ADDENDUM No. 2

RFP No. 26-08

BARTON DAM – SECURITY IMPROVEMENTS

Drawing No.
C-102

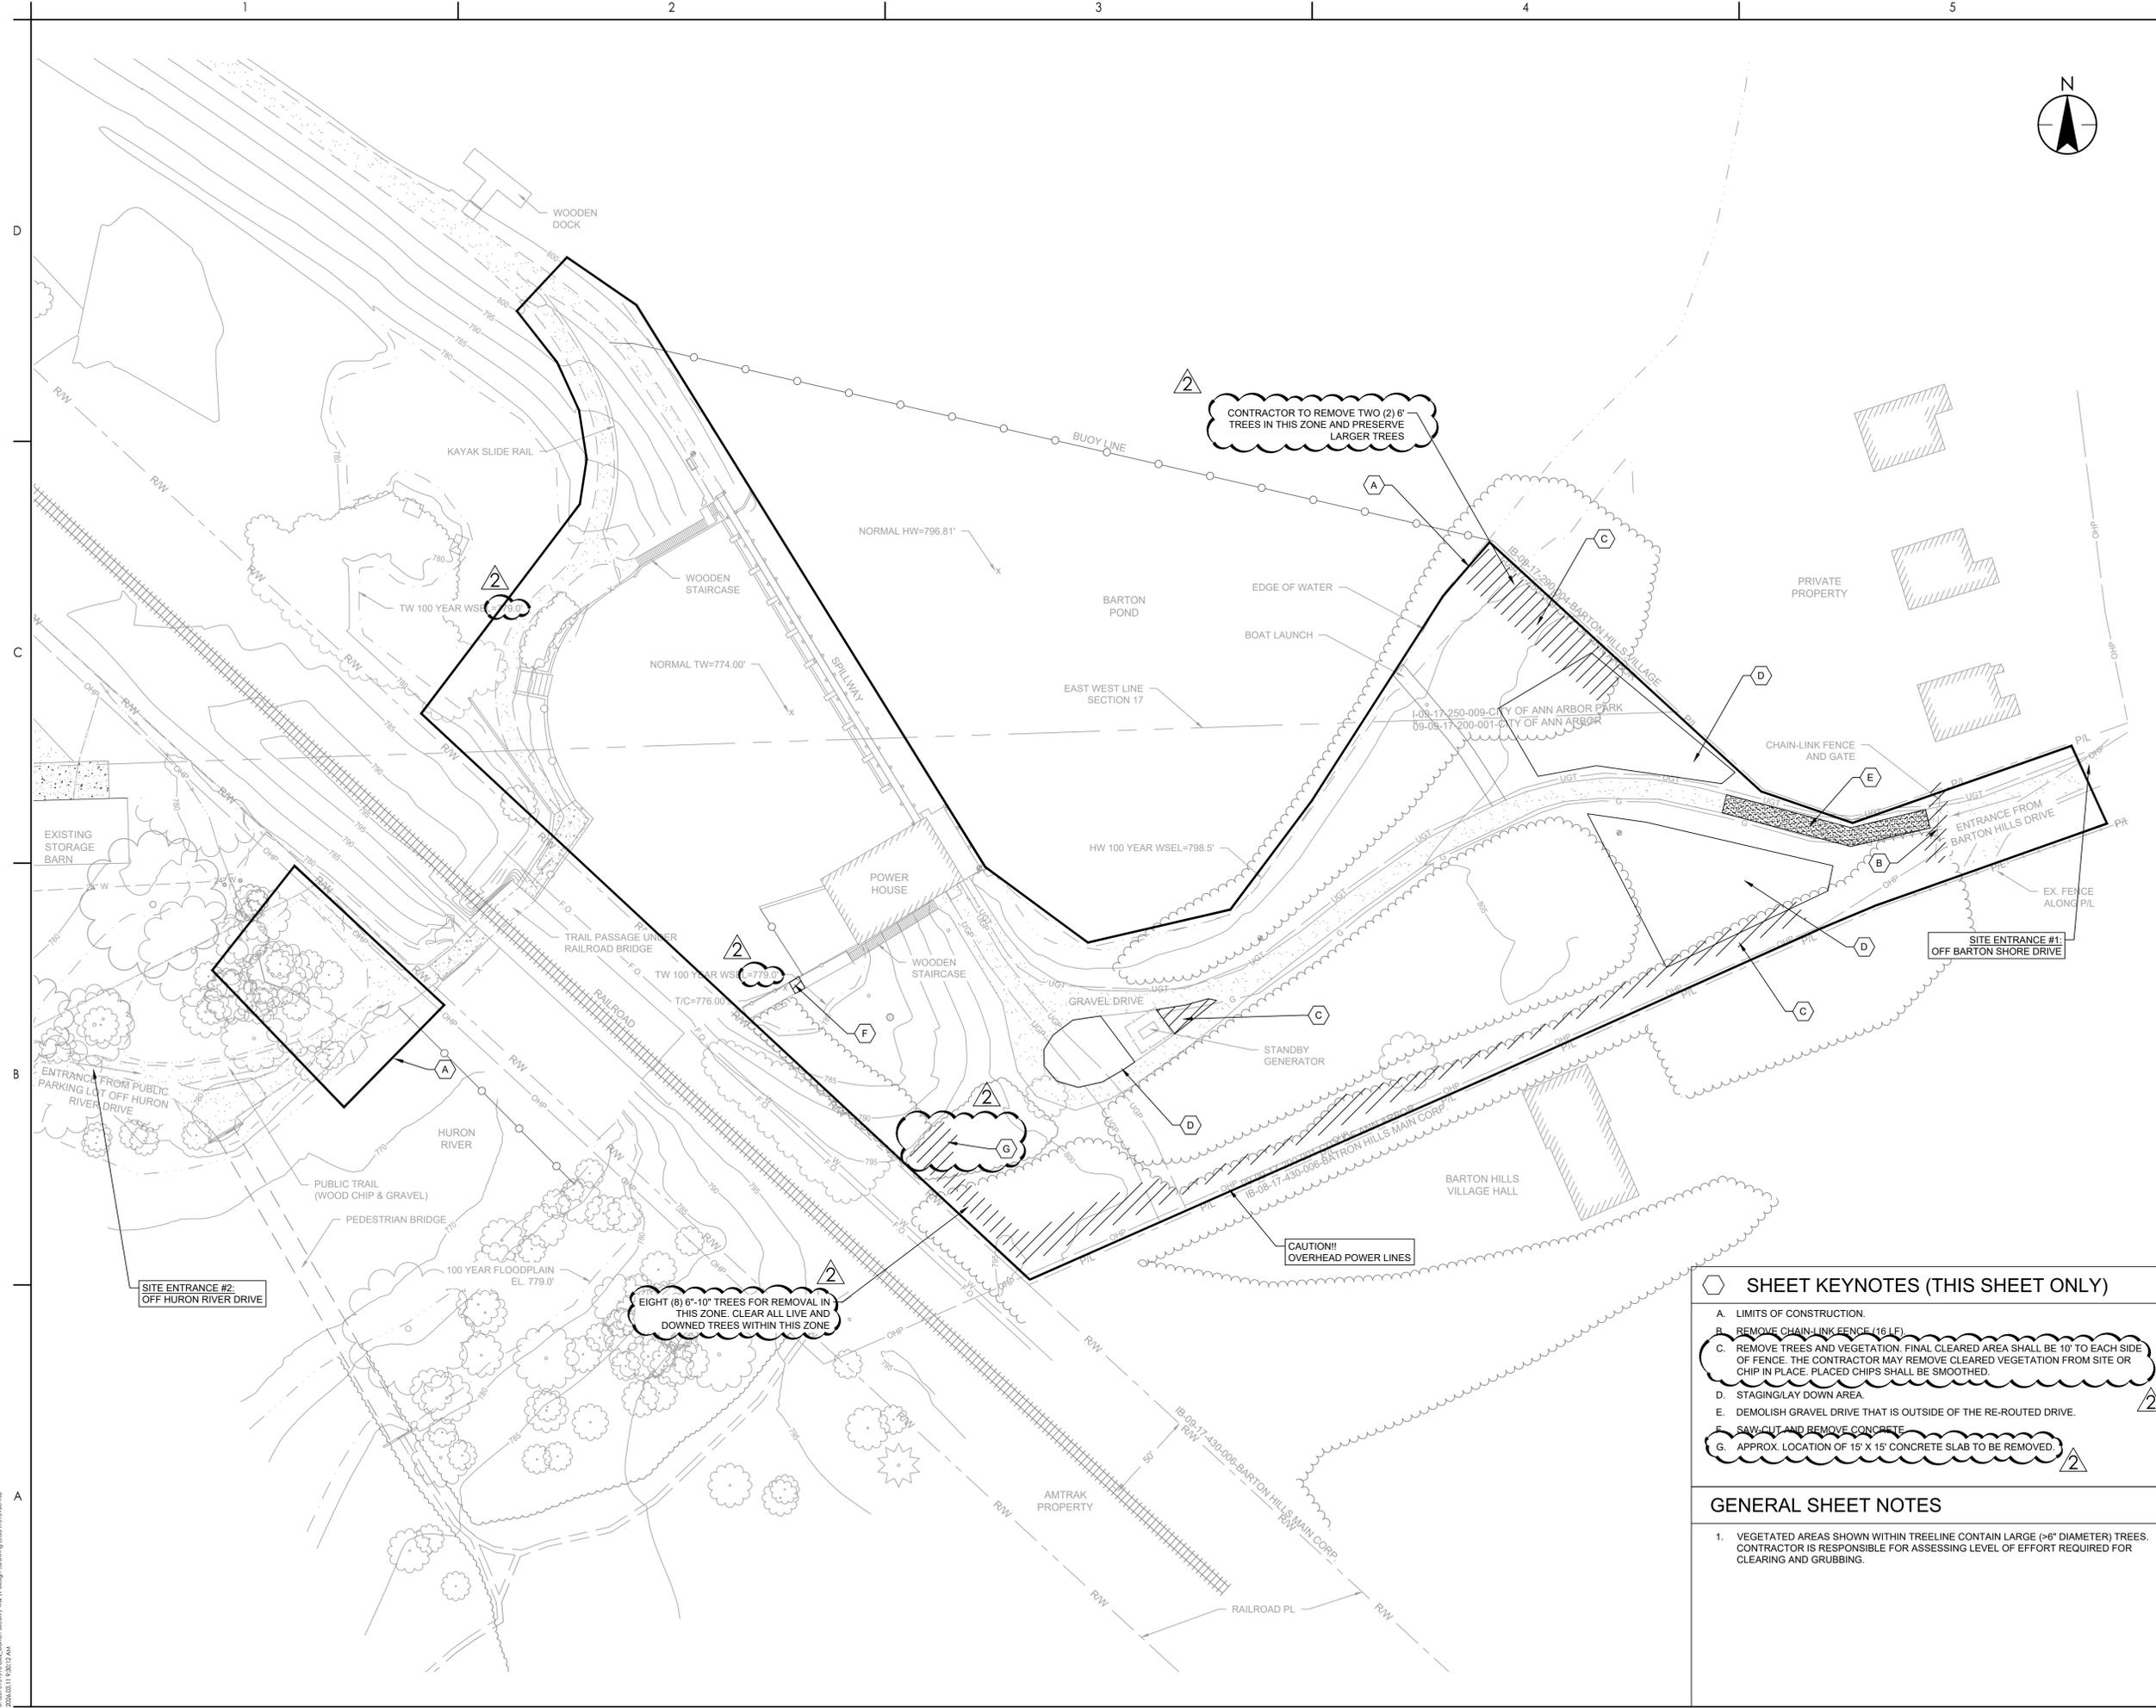
Answer 6: Please see drawing revisions on pages C-102 and C-103 clarifying removal of trees included as part of this Addendum. See also Sections 1.08 and 1.09 in General Site Provisions and Note #8 on page G-002 of the drawings for additional requirements.

CONTRACTOR TO REMOVE TWO (2) 6" TREES IN THIS ZONE AND PRESERVE LARGER TREES

EIGHT (8) 6"-10" TREES FOR REMOVAL IN THIS ZONE. CLEAR ALL LIVE AND DOWNED TREES WITHIN THIS ZONE

| Revision Sheet 0 9 of 15 | Drawing No. E-102 |

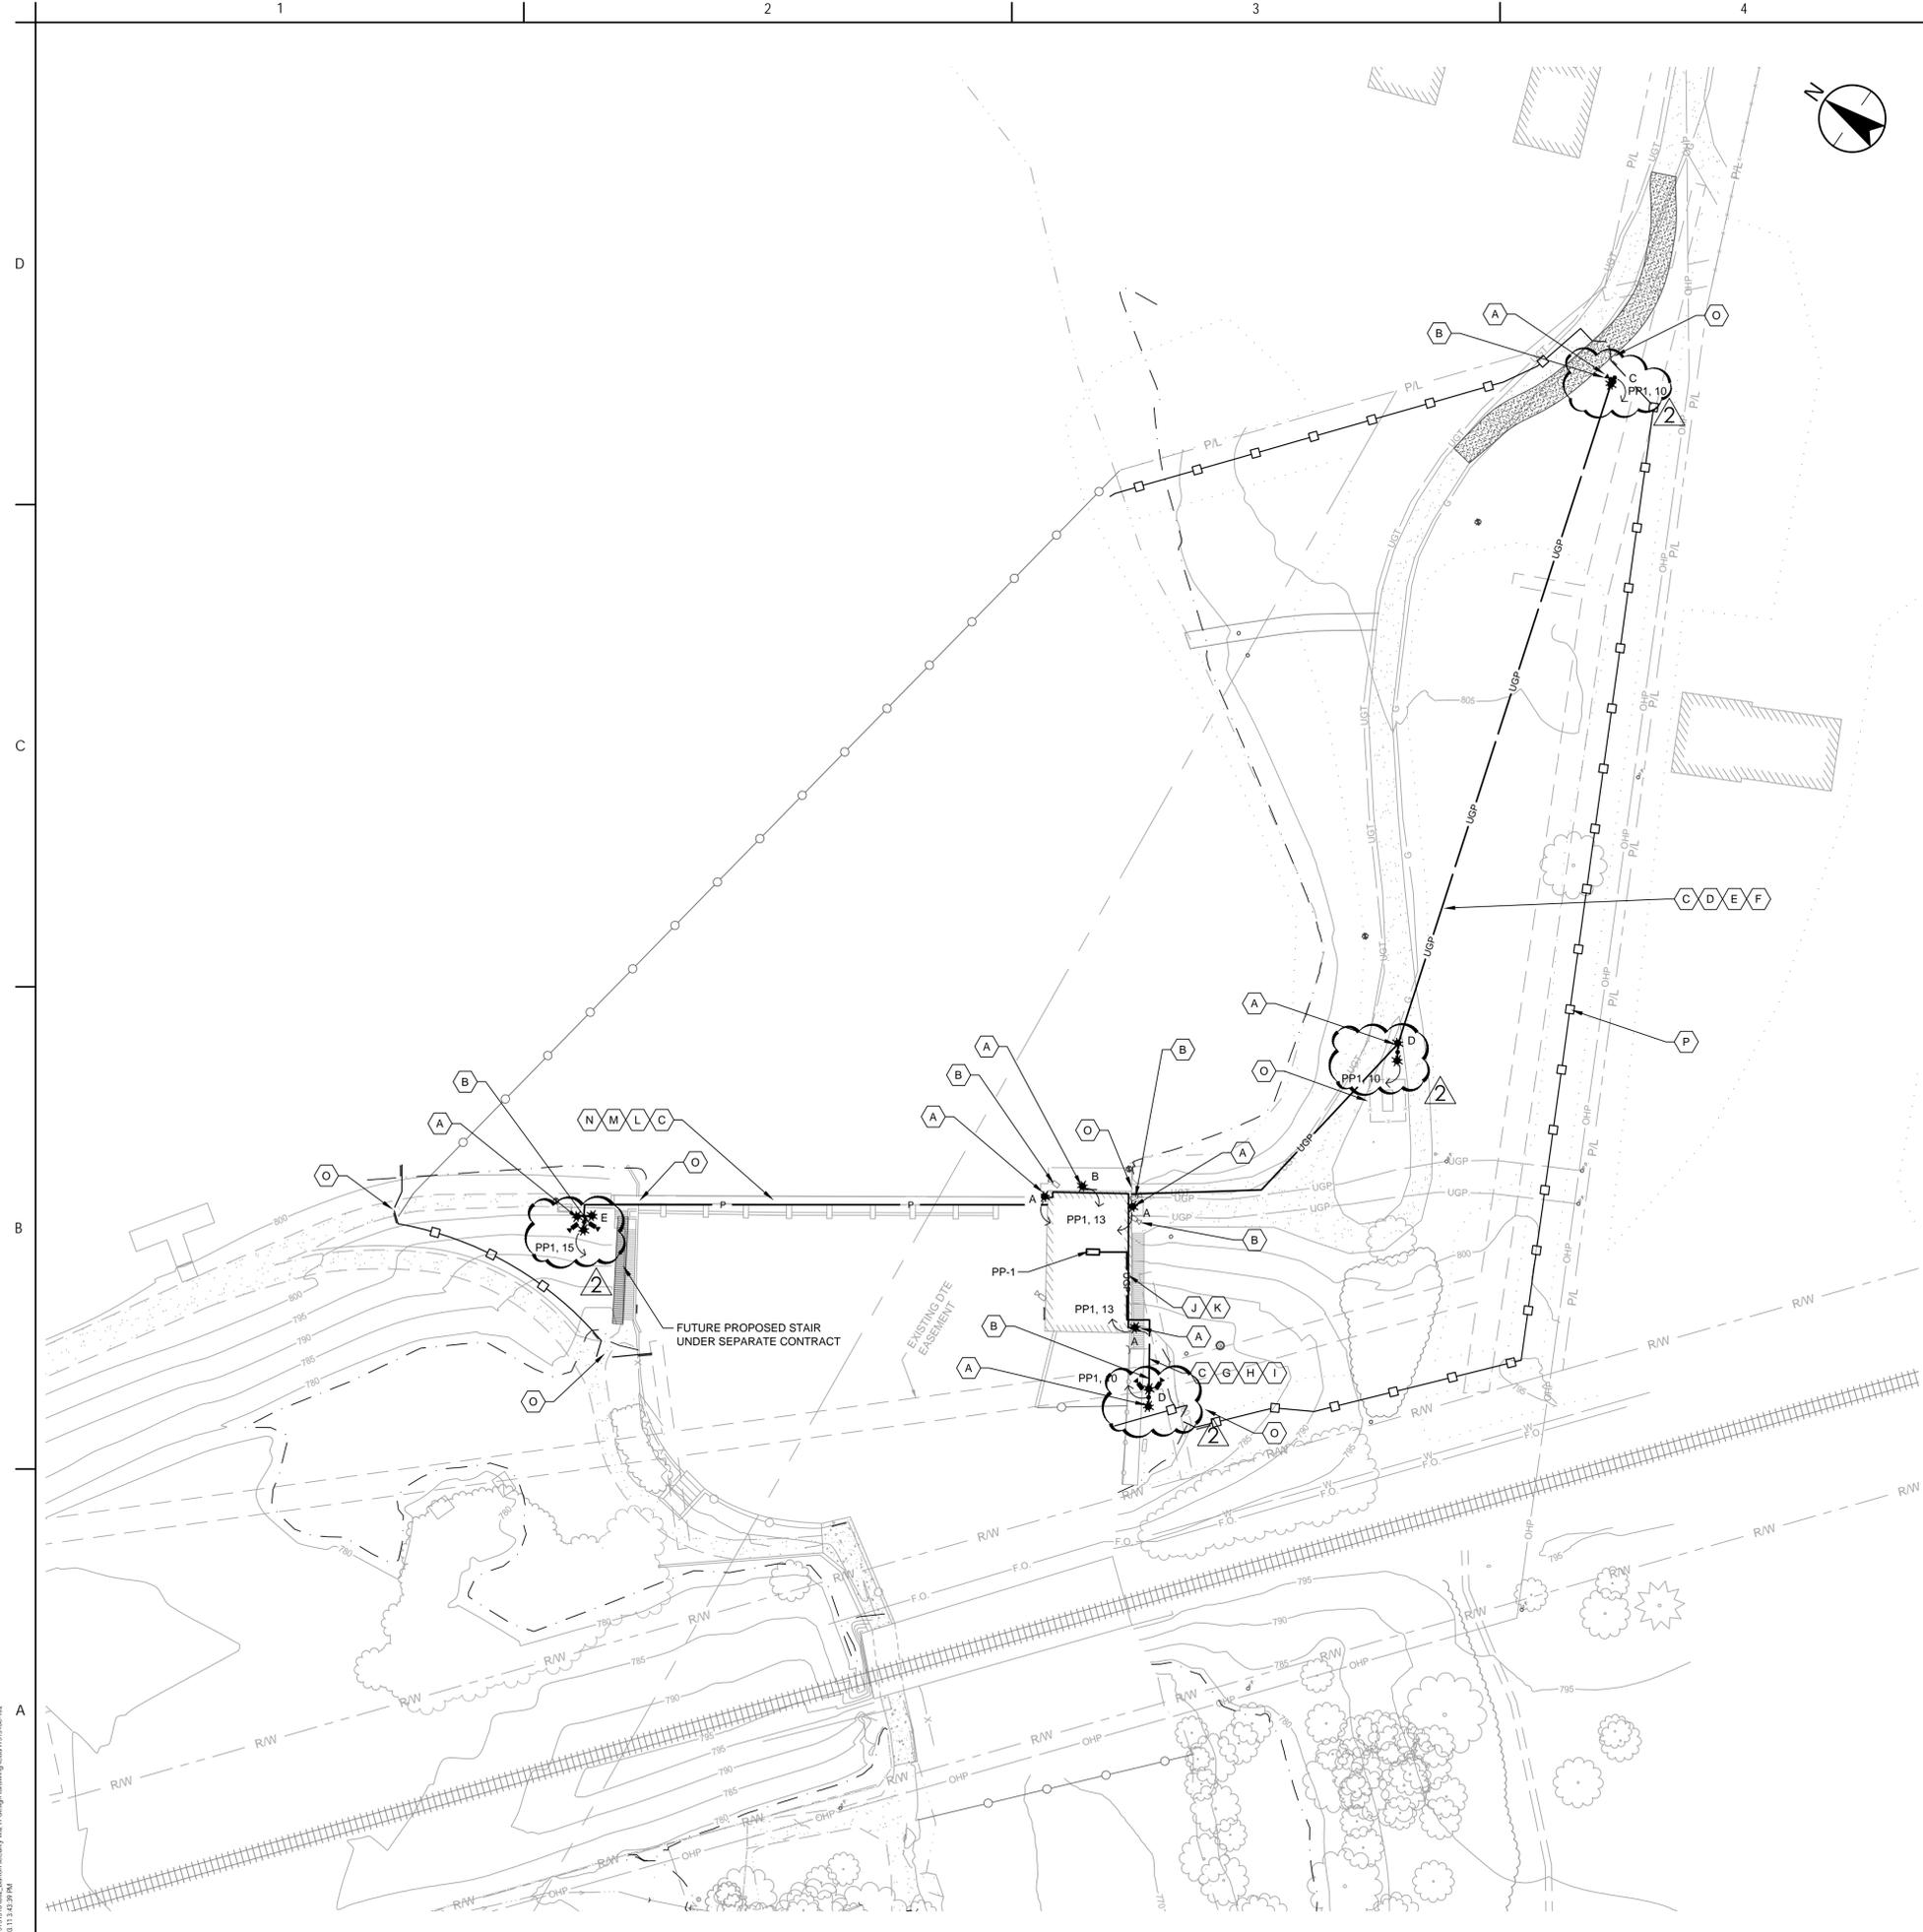
Question 3: The distance across the bridge is approximately 260'. There will need to be an electrical pullbox every 100 feet per NEC code. Is it acceptable to use Unistrut to build a supporting structure for these pull boxes on the railway?

Answer 3: Yes, it is acceptable to use a Unistrut framing system to construct a support structure for the required pull boxes along the spillway. The pull box to be installed shall be RGS (Rigid Galvanized Steel). The support system shall be securely anchored and designed to withstand anticipated environmental loads. No penetrations are permitted in the concrete; the spillway frame shall be used for support. Submit proposed mounting details and attachment methods for Engineer review prior to installation

Project No. 2075151516
Revision Sheet 0 10 of 15
Scale 0' 2' 4' 8'
Drawing No. E-301

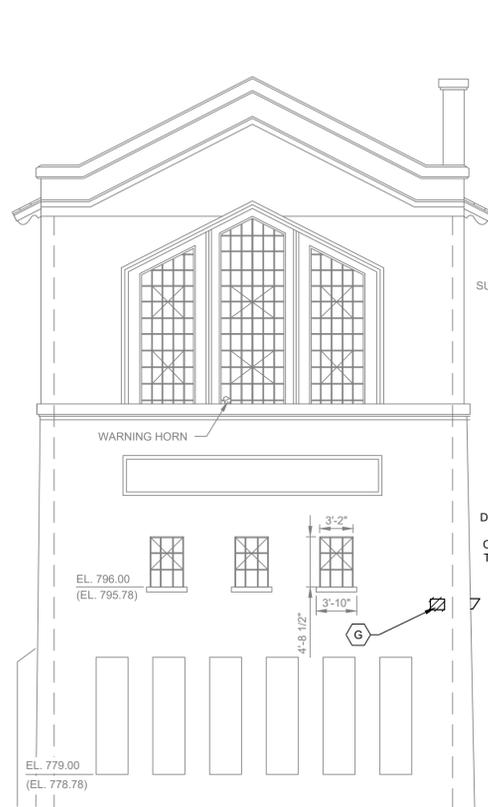
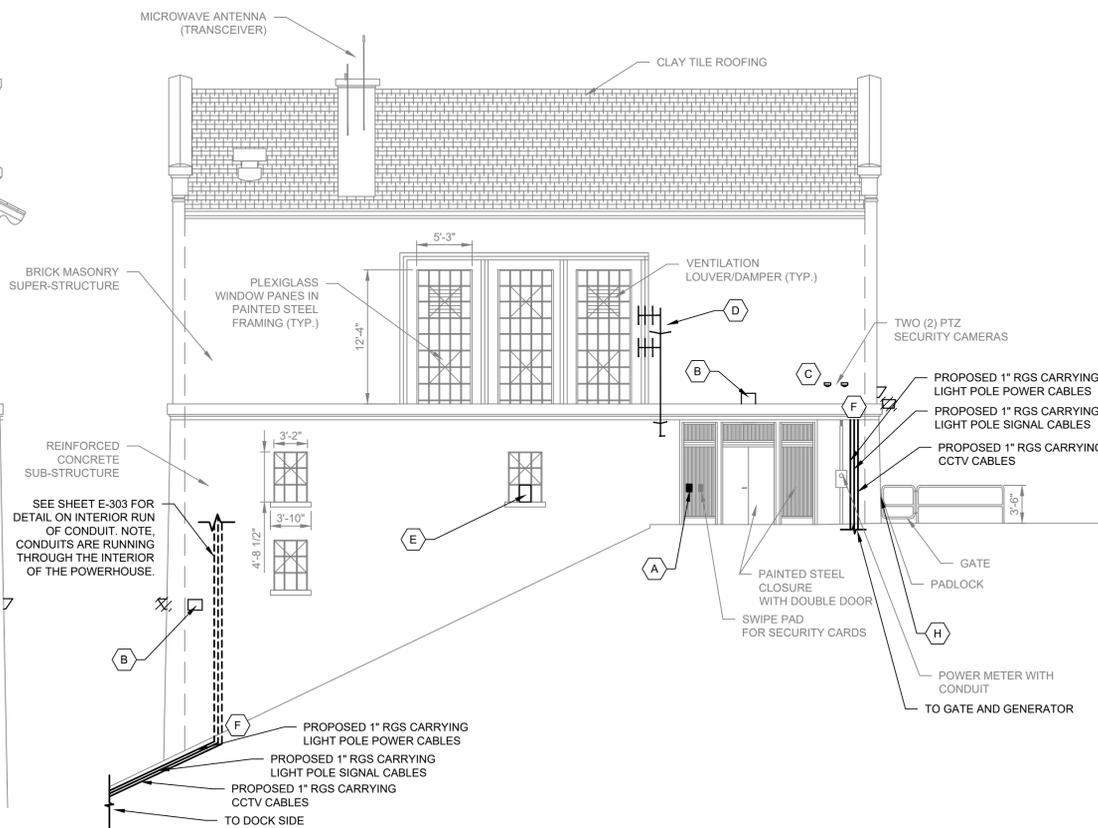
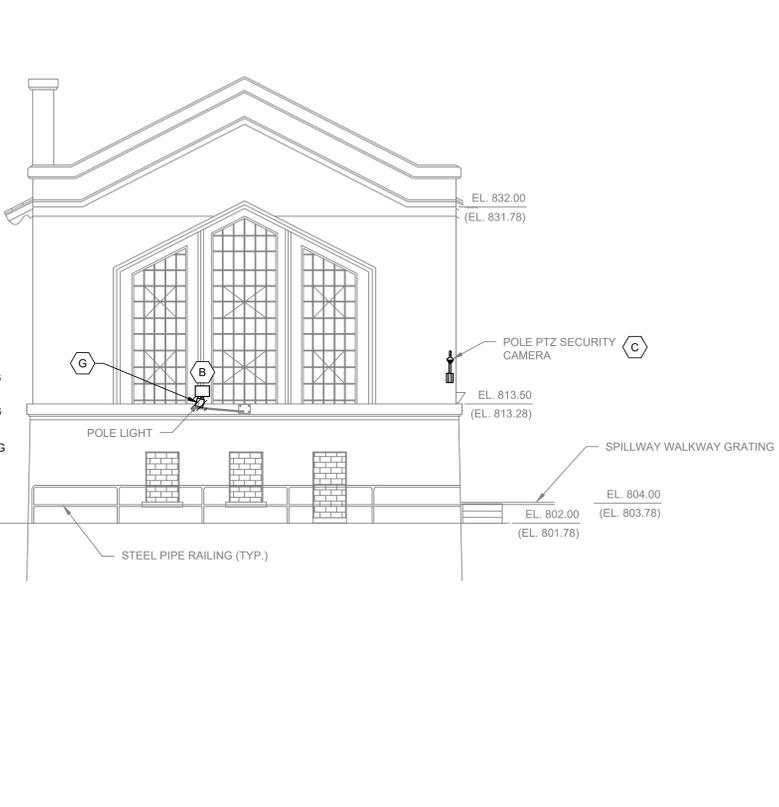
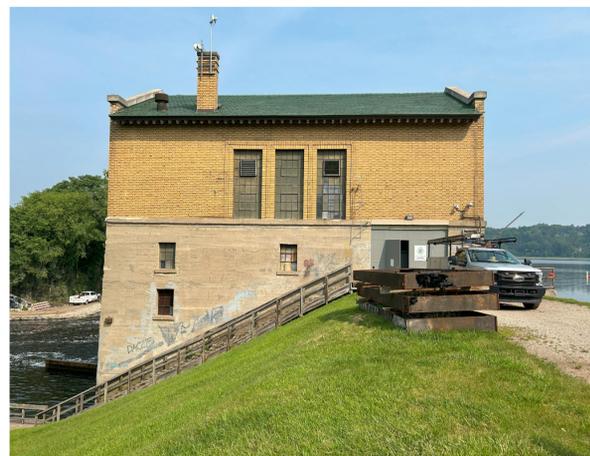
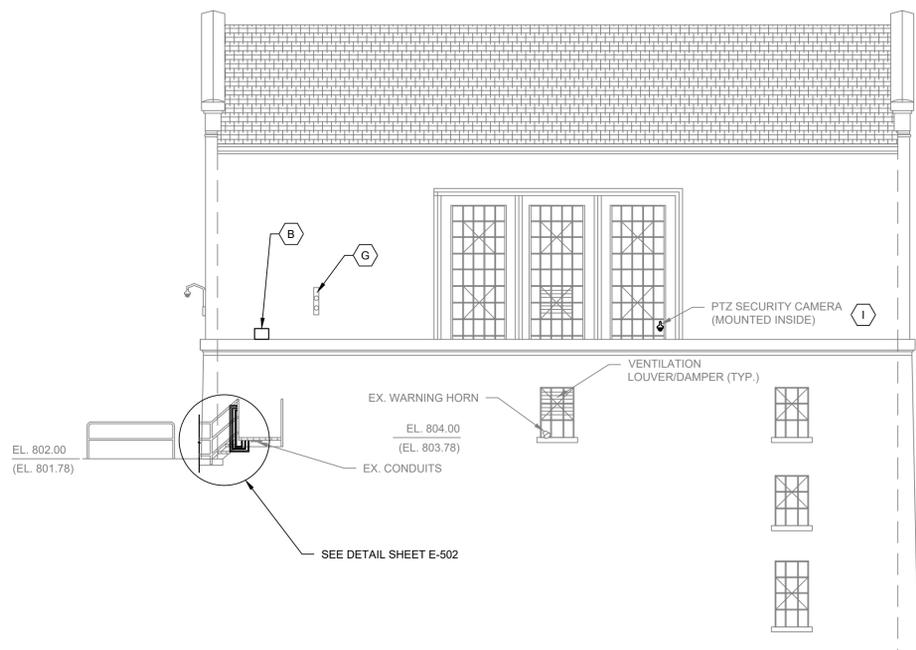
Question 7: Have the windows been tested for lead and asbestos?

- E. REPLACE BROKEN/MISSING WINDOW PANES (APPROX. 20 TOTAL) IN VARIOUS LOCATIONS AROUND THE BUILDING ENVELOPE. TYPICAL GLASS SIZE = 10" x 12". FIELD MEASURE ALL PANES. INTERIOR SCAFFOLDING OR LADDER MAY BE NEEDED FOR HIGHER GLASS PANELS.

- H. INSTALL SECURITY LOCK AT GATE.
- I. CAMERA SHALL BE MAINTAINED AS FUNCTIONAL DURING CONSTRUCTION.

Answer 7: Windows were tested for asbestos and the result was negative for items tested. Please see attached results. The contractor shall assume that the window frames and surrounding brick have lead paint. A lead abatement specification has been included in this Addendum.
